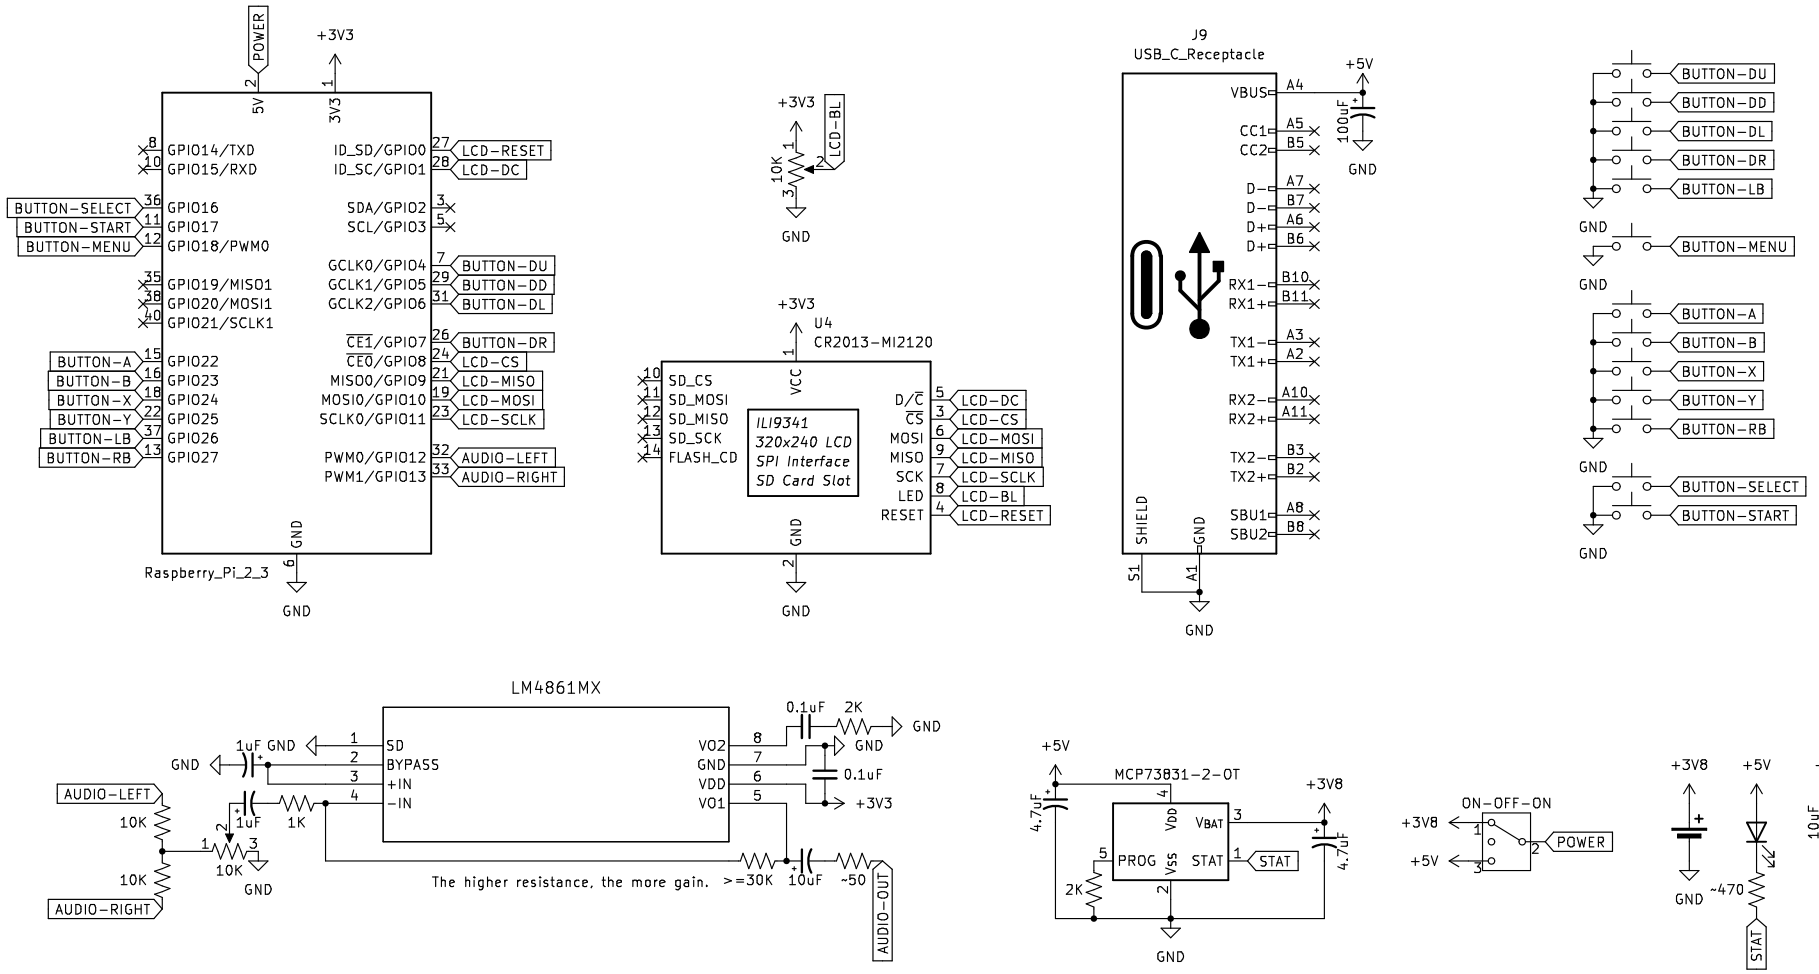
Cut trace between power switch and 5V line, making it only on/off.
DD and DR gpio pins are swapped?

Audio amplifier doesn't boost enough for external speaker,
even with higher gain resistors
